District Office- Tenant Improvement

981 Ridder Park Drive, San Jose, CA 95131
MDG Project # 2203

MECHANICAL UPGRADES – BID #B-03-2022-23
ELECTRICAL UPGRADES – BID #B-04-2022-23
GENERAL CONSTRUCTION – BID #B-05-2022-23

October 21, 2022

**FLOOR PLAN
SECOND FLOOR**

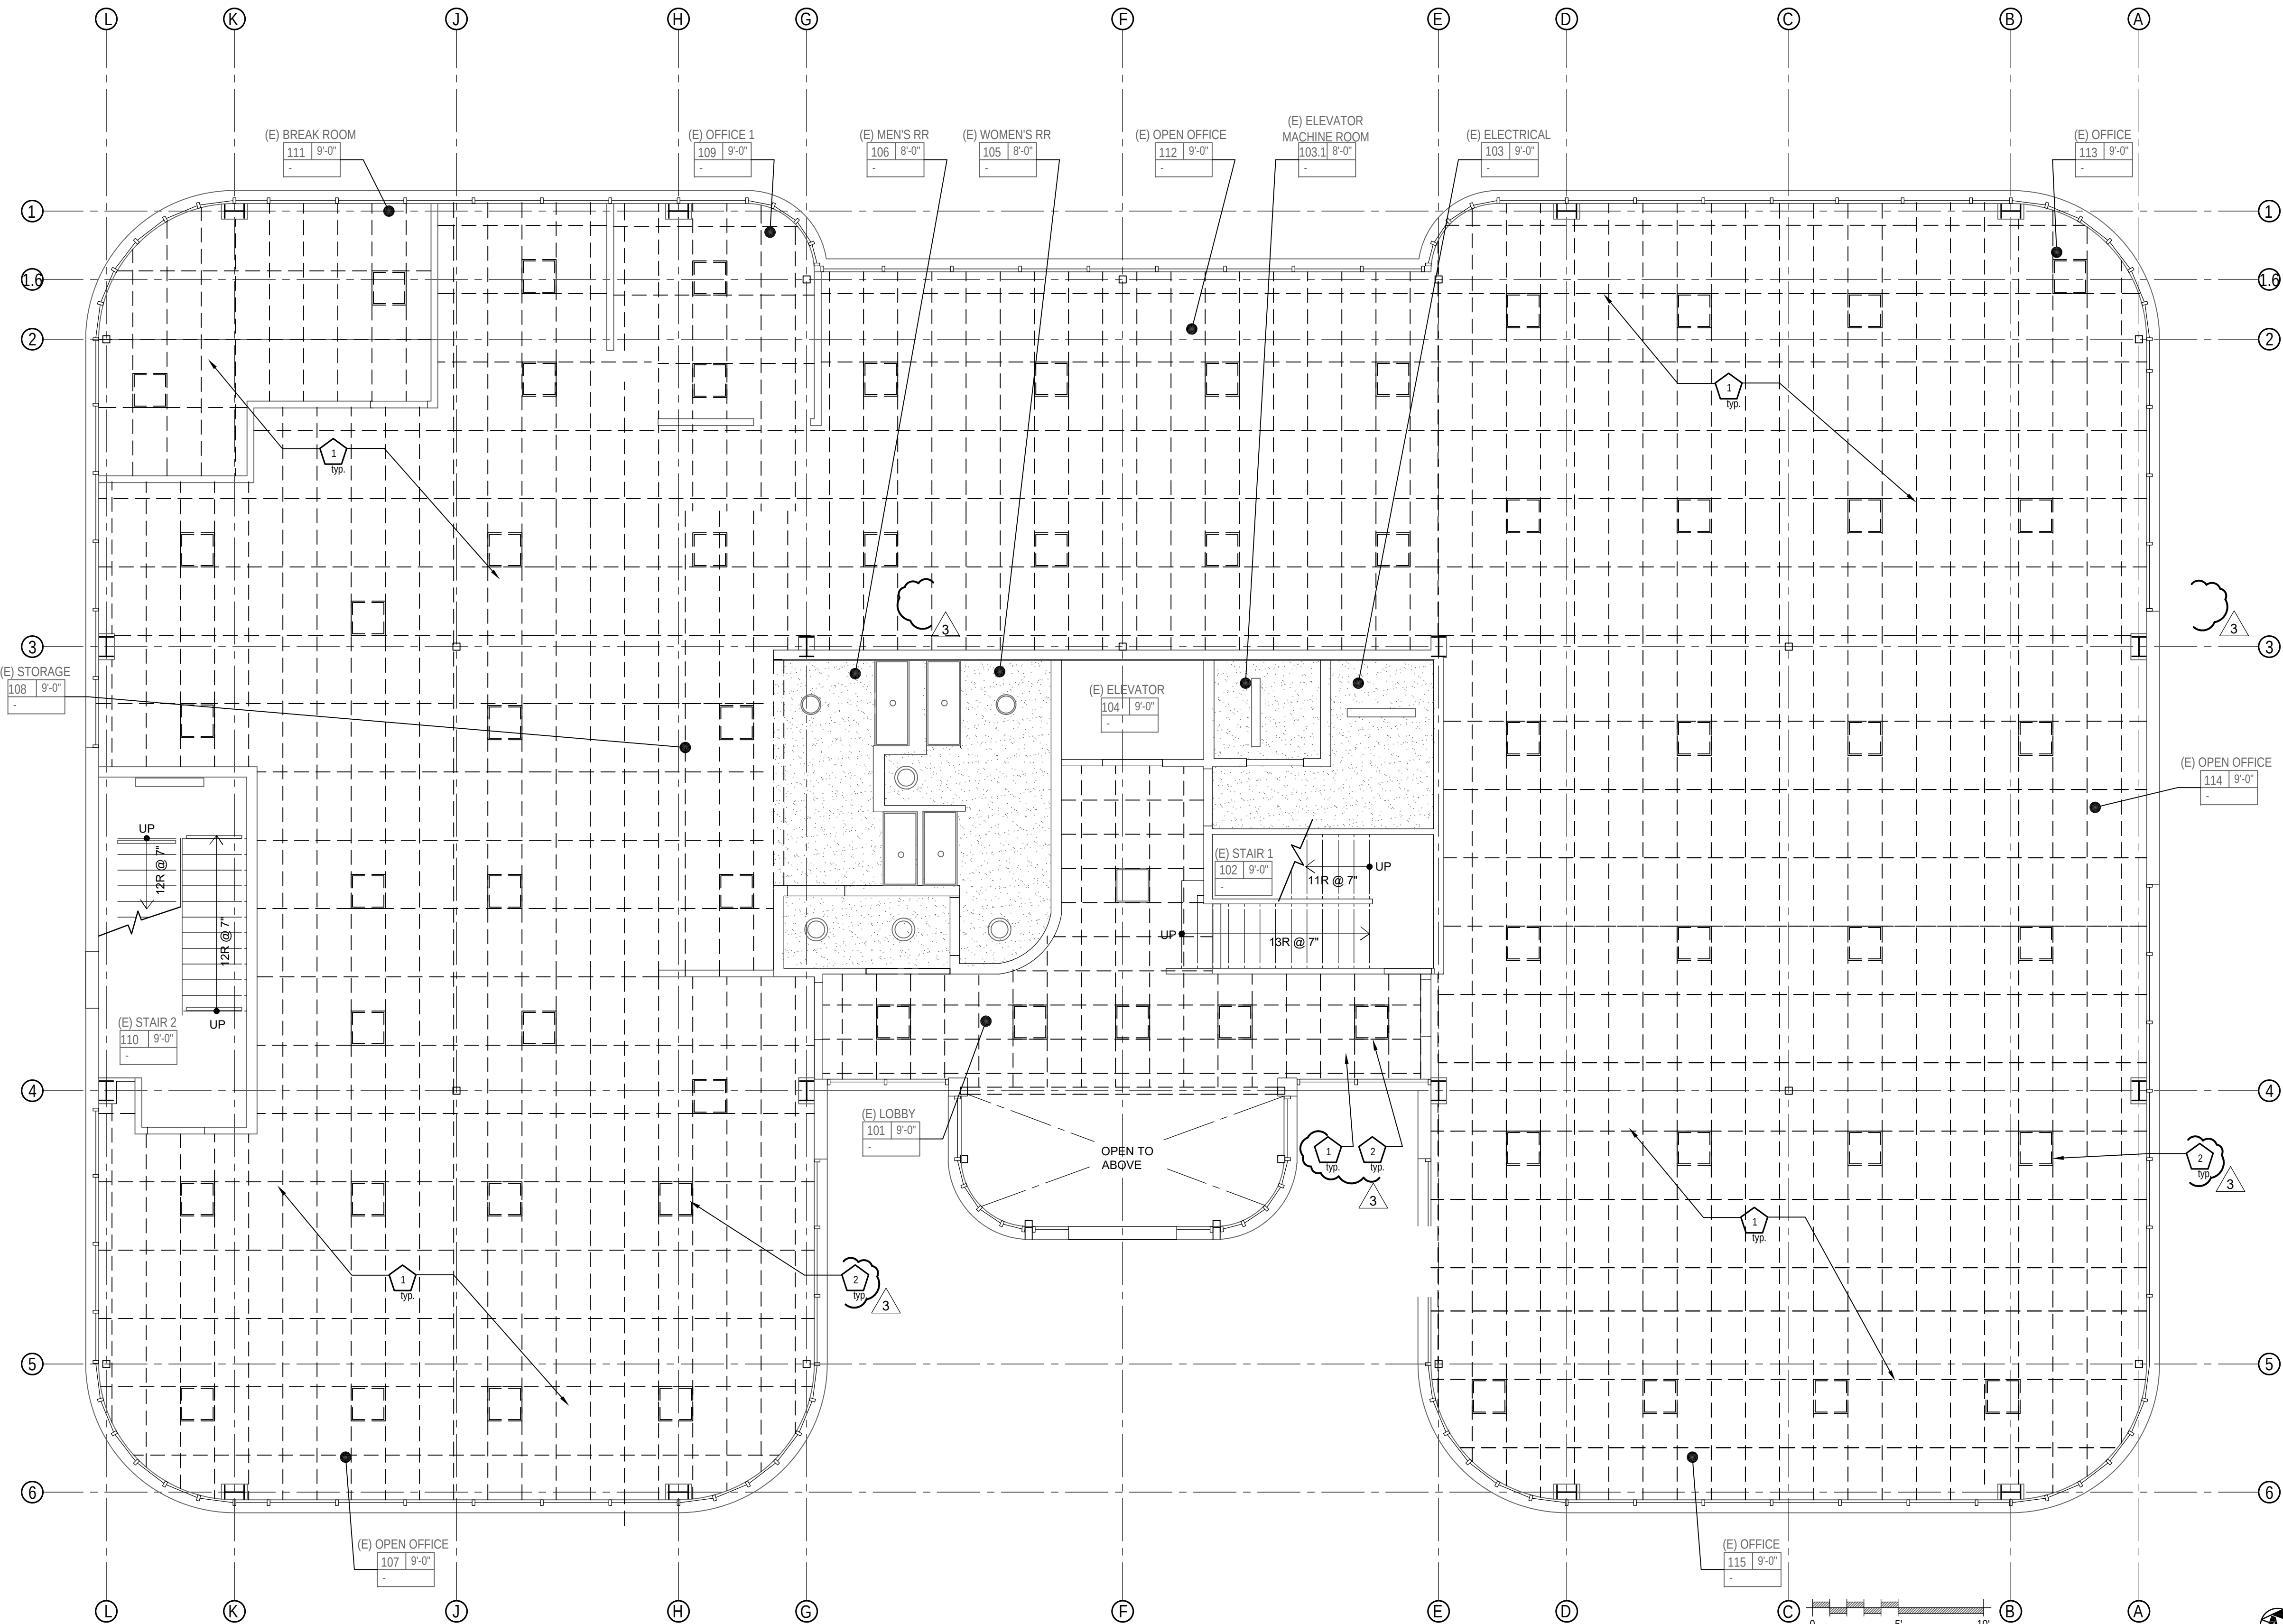
Item 5: Sheet 3.2 Floor Plan- Second Floor

- A. See added wall hatch at Men's RR 206- West Wall.
- B. Door location is existing to remain in Office 216.
- C. Provide concrete infill where existing shower and curb were removed at IT 219.
- D. Add a 24" deep countertop outside of Storage 223 and see revised layout.
- E. Remove tv monitor at Conference 224.
- F. Add sink as shown in Break Room 225
- G. Add a 24" deep countertop at the west wall in Storage 226.
- H. Relocate tv monitor from south wall to north wall at Conference Room 228.
- I. Remove Storage 230.1 and closet shelf and pole keynote 10.01.

DEMOLITION
REFLECTED CEILING PLAN
FIRST FLOOR

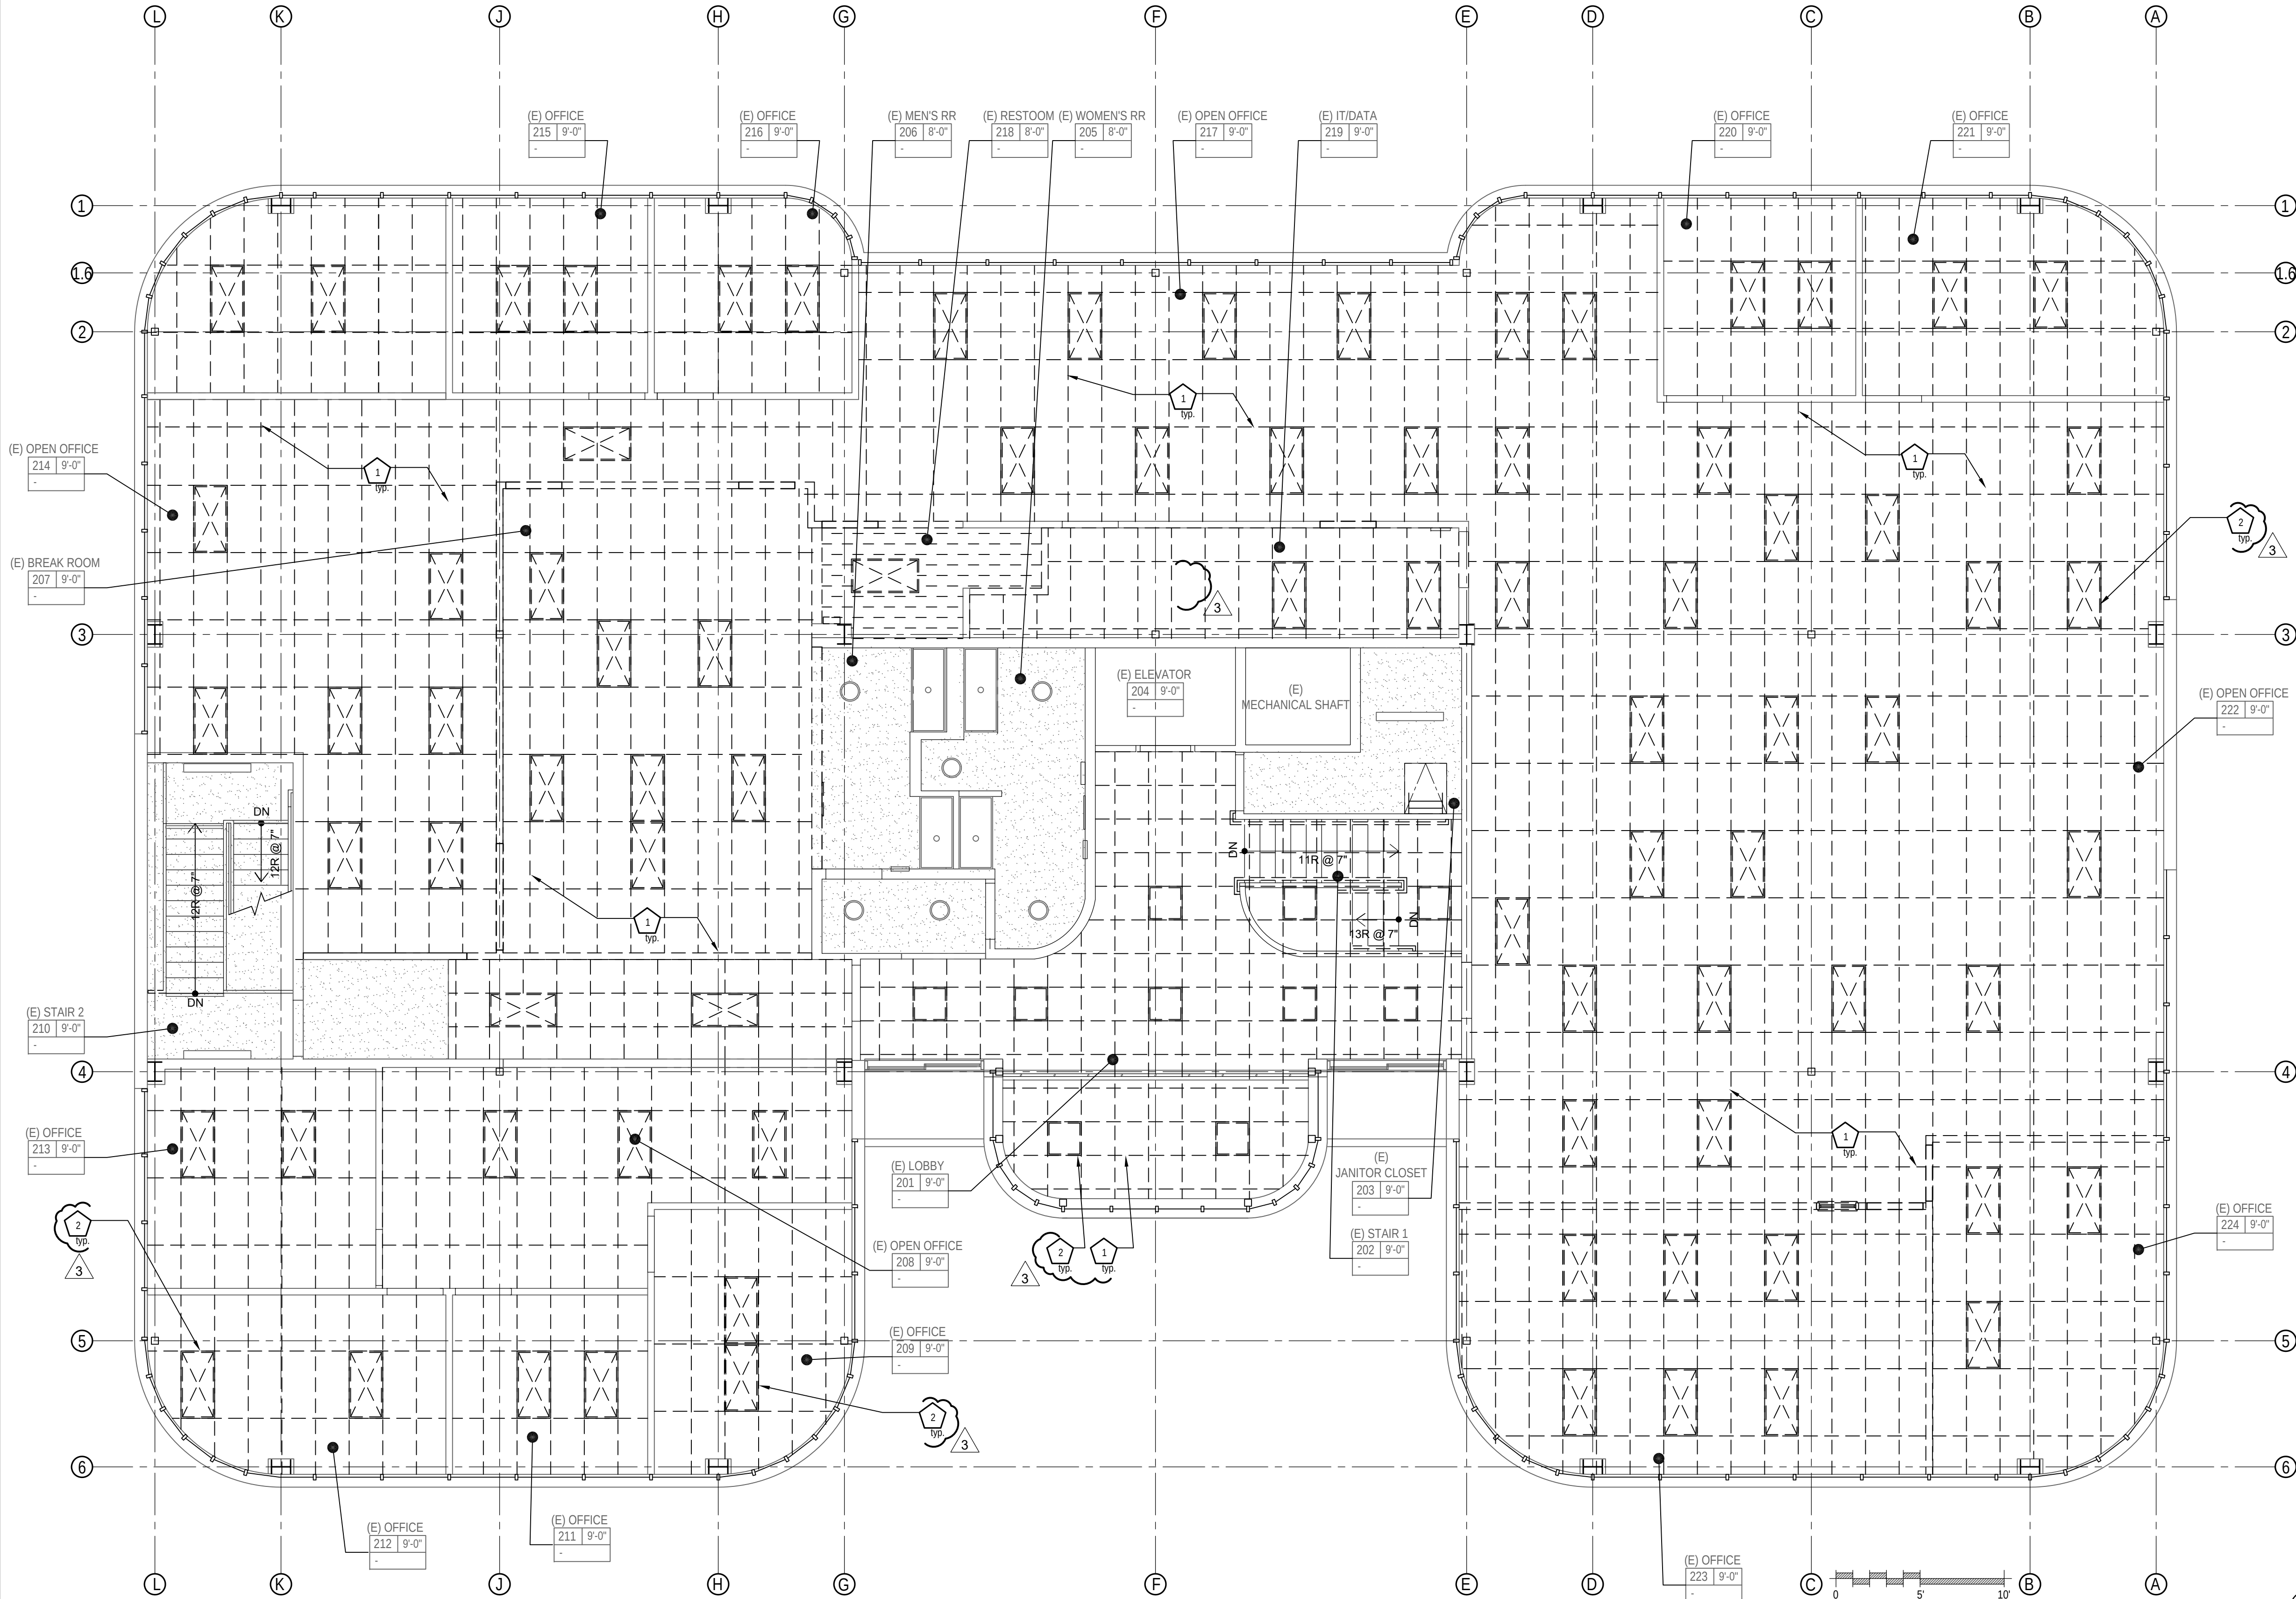
Item 6: Sheet 4.1 Demolition Reflected Ceiling Plan- First Floor

- A. Clarification- Entire existing t bar grid, ceiling tiles are to be removed and disposed by others. Existing light fixtures will be removed by others, stored by the District and Contractor is to reuse light fixtures and provide installation, OFCI.

DEMOLITION
REFLECTED CEILING PLAN
SECOND FLOOR

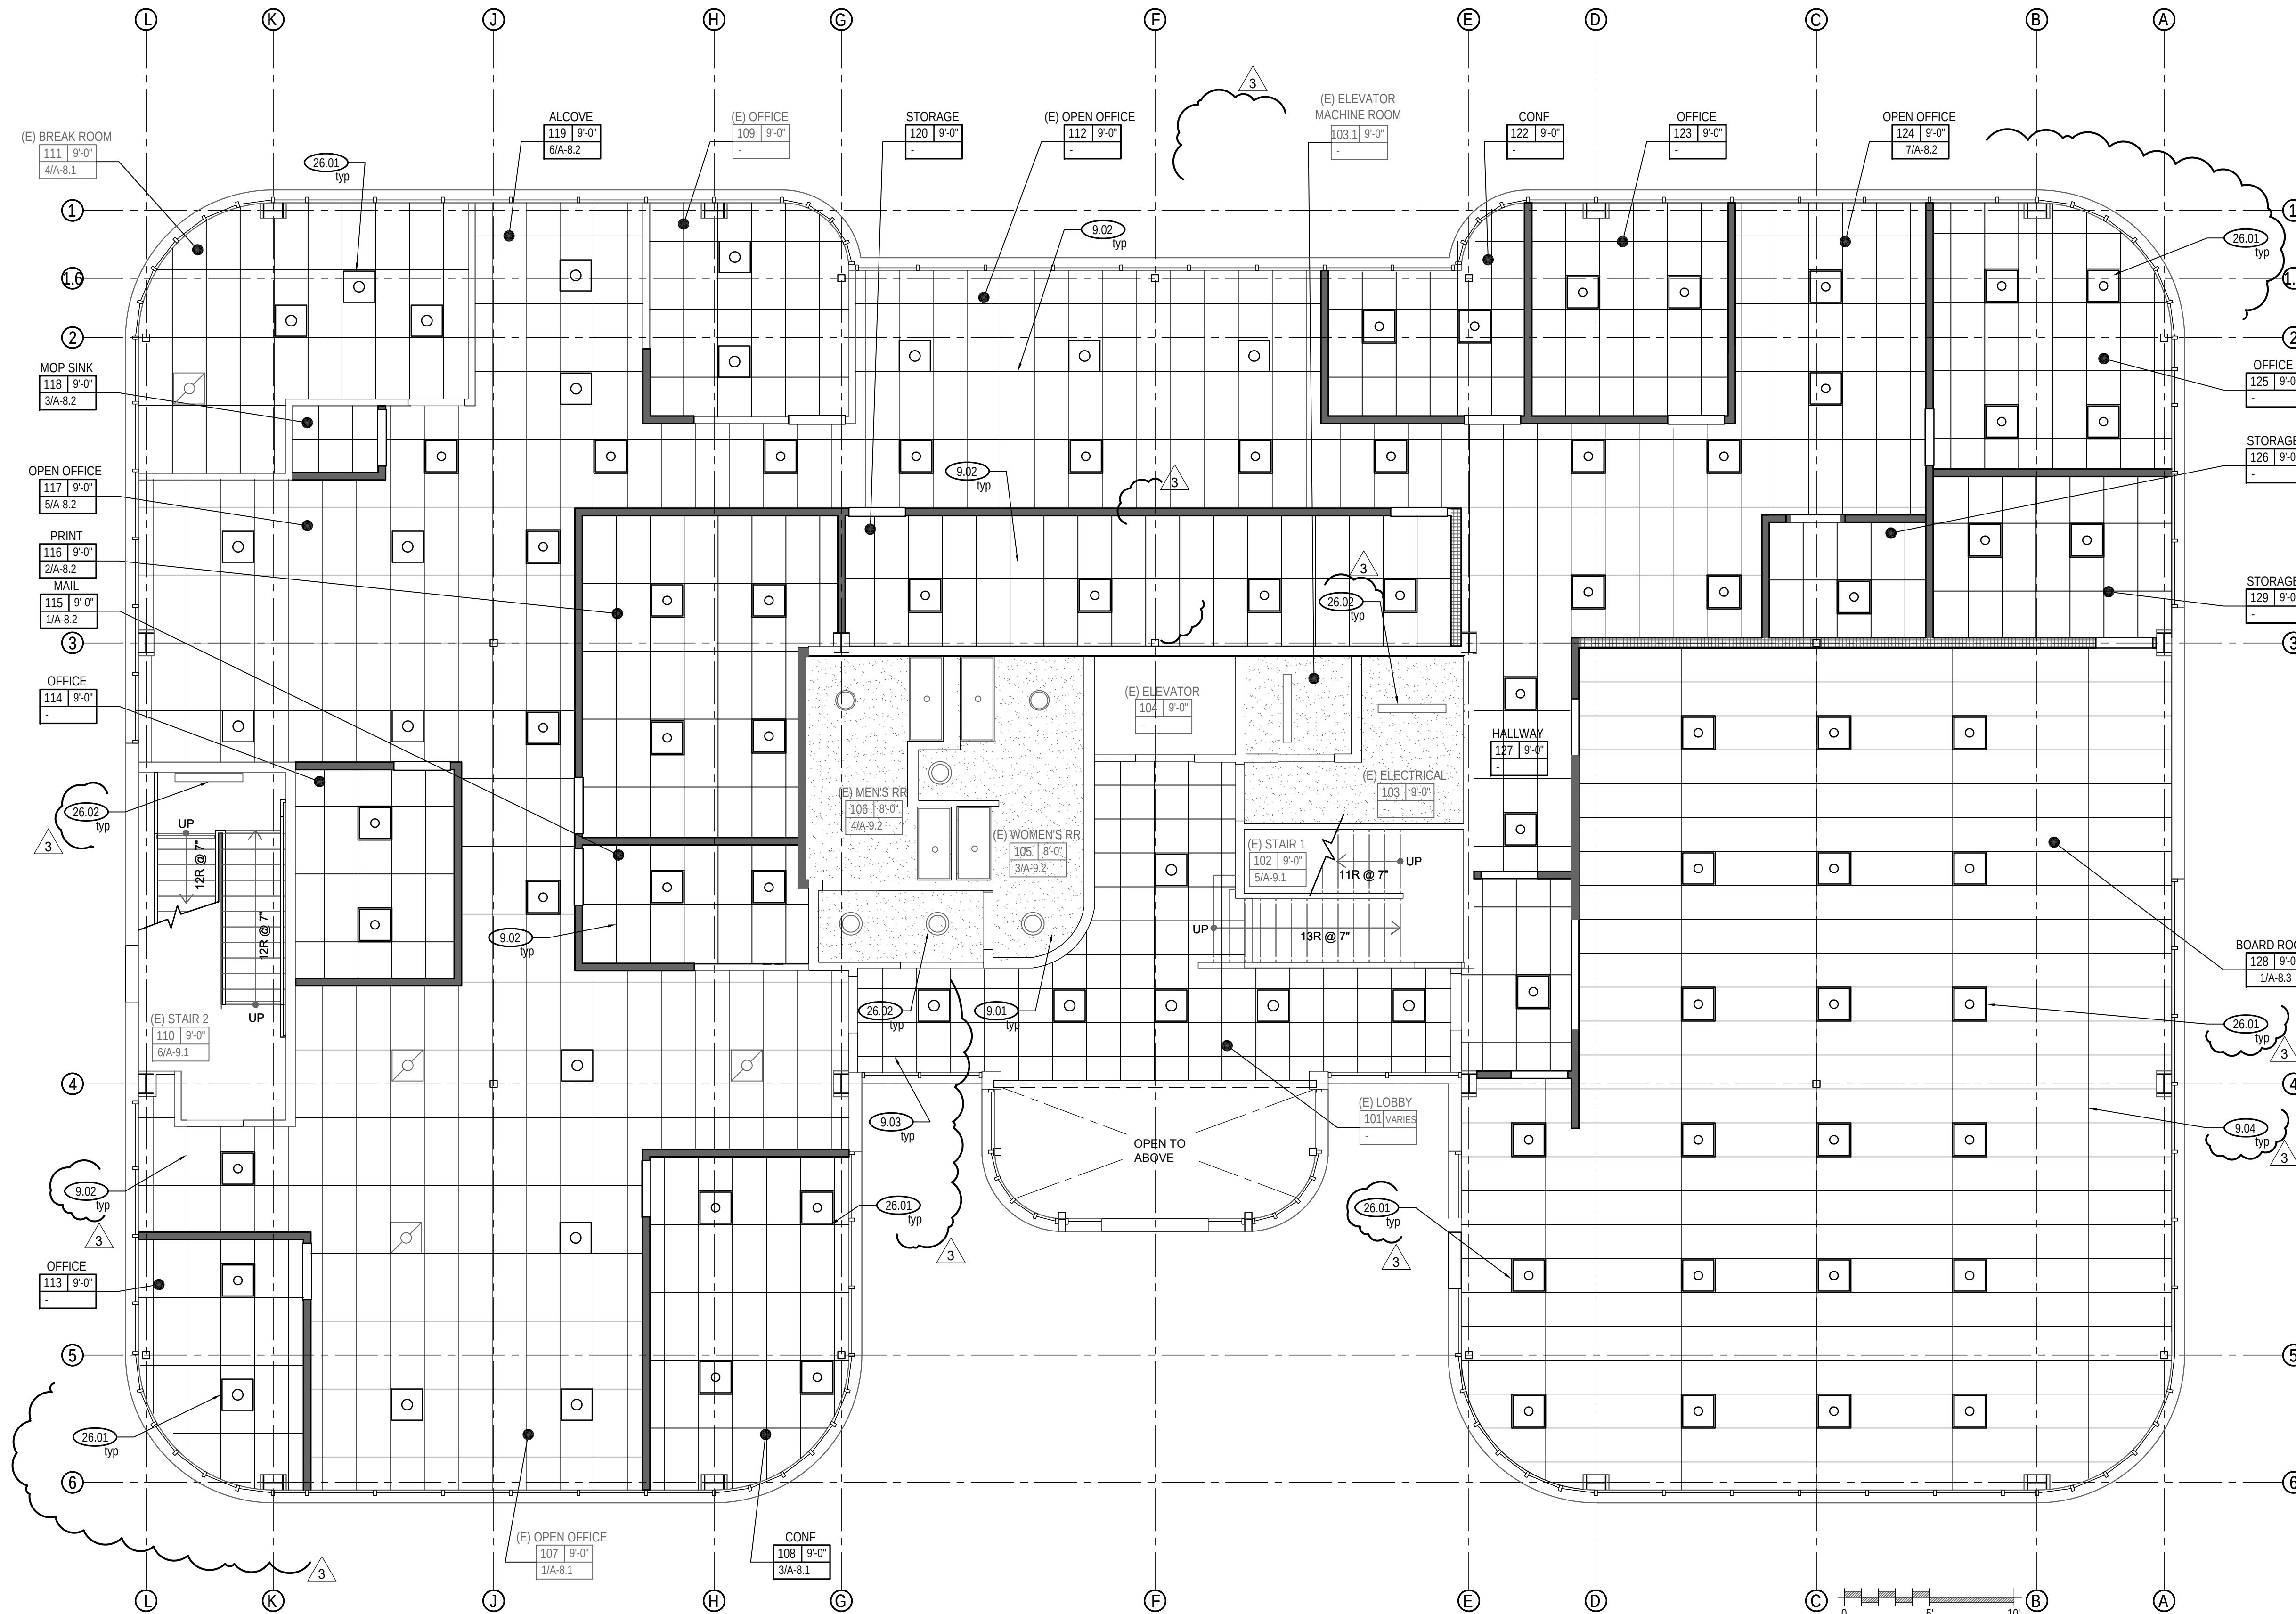
Item 7: Sheet 4.2 Demolition Reflected Ceiling Plan- Second Floor

- A. Clarification- Entire existing tbar grid, ceiling tiles, and light fixtures are to be removed and disposed by others.
